**SERVICE BULLETIN**

SB No. 100 Issue No. 2

TITLE WATER INGRESS INTO COCKPIT FROM ECS FRAME 2 BAY**CLASSIFICATION**

This S.B.100 is re-written to incorporate references to the 'Y' piece Post Mod M680B.

FIG 1
VIEW LOOKING UP ONTO UNDERSIDE OF FRAME 2

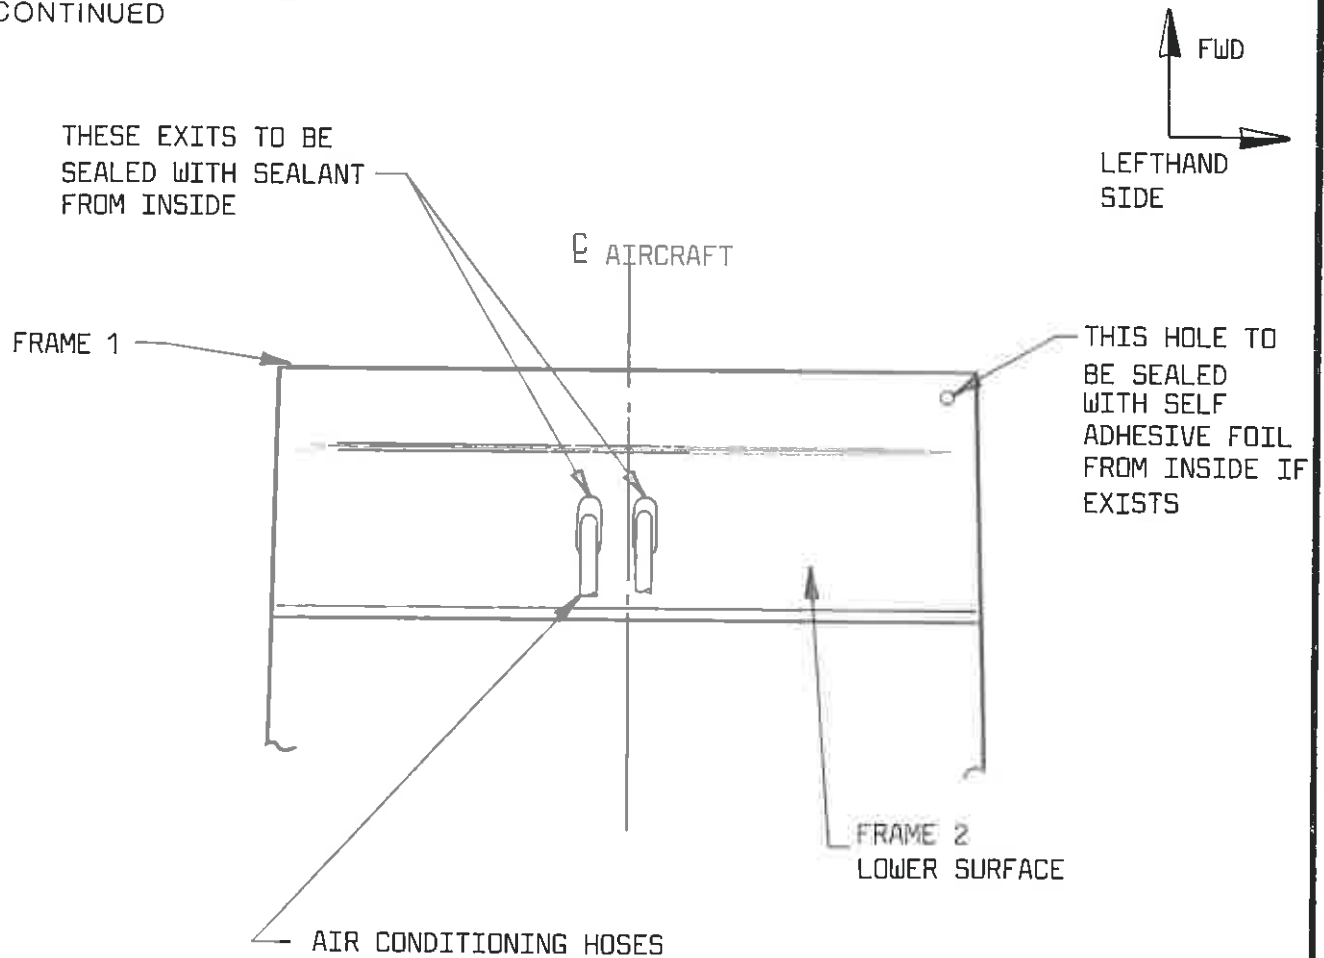
Cases have occurred of water ingress into cockpit from Frame 2 bay which houses the ECS evaporator. Upon further investigation it was found that the bay had not been sealed.

1. From the underside of Frame 2, check suspect areas for sealant. Refer Fig. 1.
2. If holes are visible gain access into Frame 2, remove any water, clean and degrease around areas to be sealed.
 - 2.1 Apply sealant RTV 781 (or 732 or 786) around air conditioning rubber hoses. This action is part of Mod M501A.
 - 2.2 If hole exists at forward left hand side of bay floor, then from a sheet of aluminium self adhesive foil, cut a blank approx. 1/2" oversize than the hole and bond into position.

FIG 2
VIEW LOOKING FORWARD ONTO AFT FACE OF FR 1 - R H SIDE

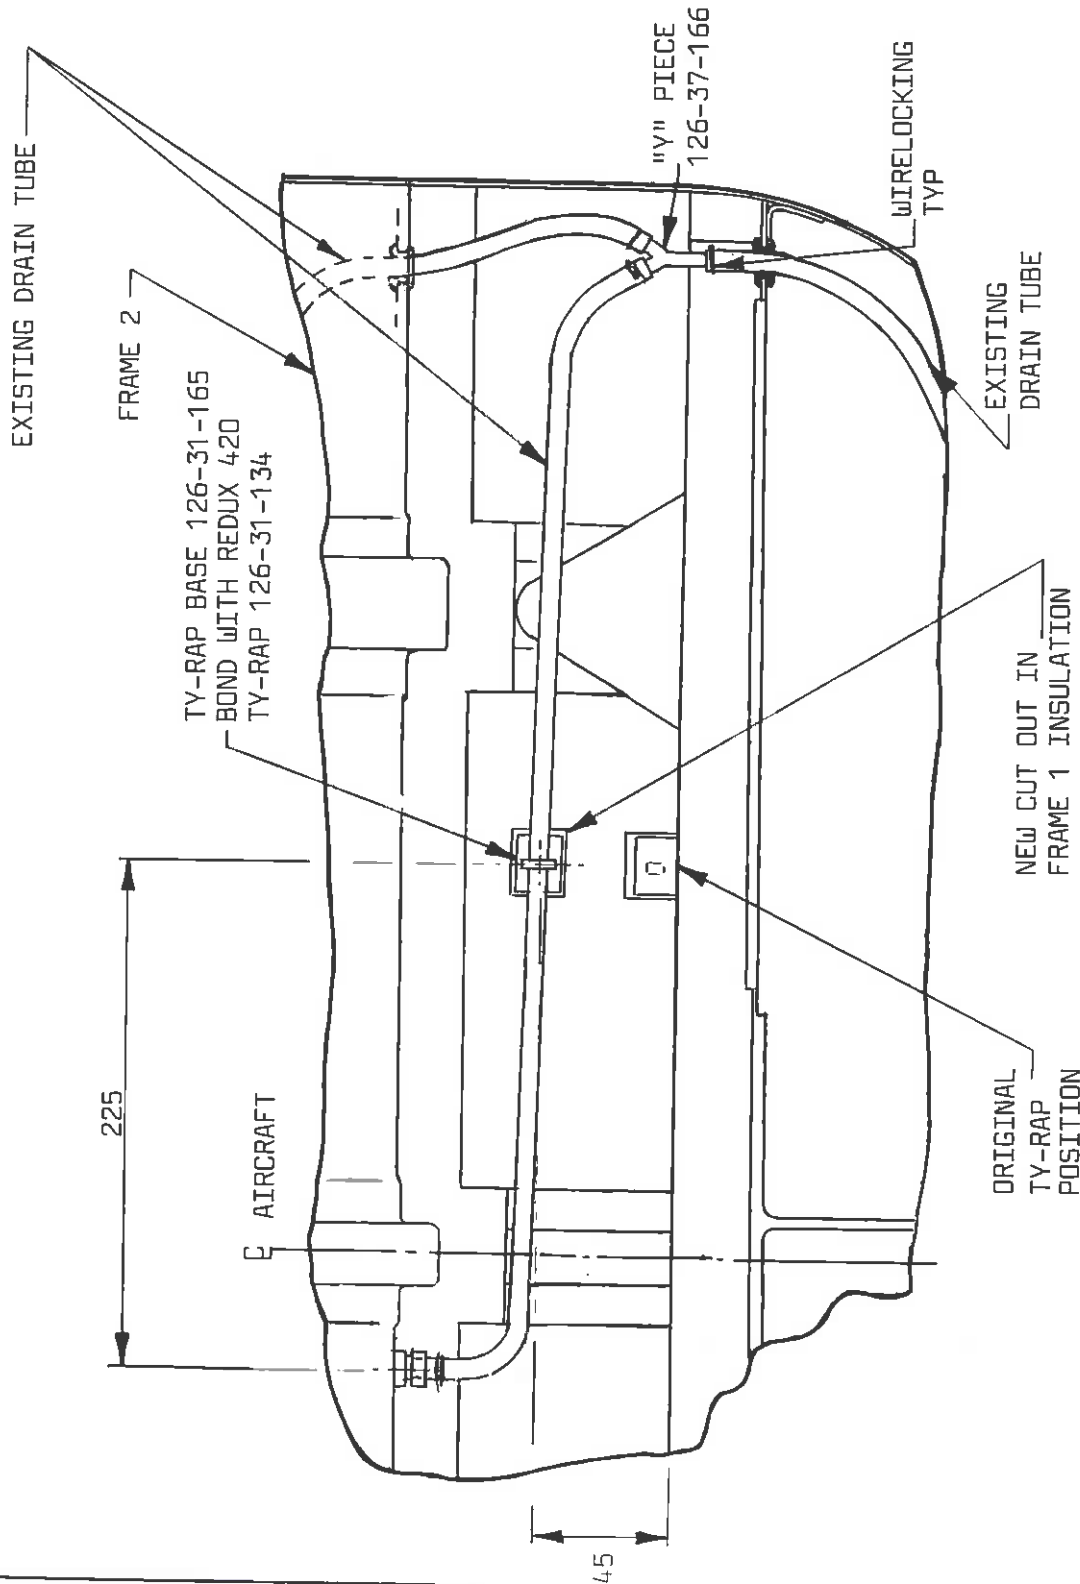
In addition, to assist in draining any accumulated water in the ECS bay, the drain line is altered to accommodate a 'Y' junction piece in lieu of 'T' piece.

3. Refer Fig. 2. Gain access to right hand side of Frame 1 aft face, clip ty-wrap holding drain tube, mark new ty-rap base position and remove required insulation, bond new ty-rap base, 126-31-165, into position using Redux 420. Allow to cure.

Remove 'T' piece and replace with 'Y' piece, 126-37-166, wirelock to secure. Ty-rap drain tube to new ty-rap base with ty-rap 126-31-134. Ensure drain tube has minimal water traps. This action incorporates Mod M680B.
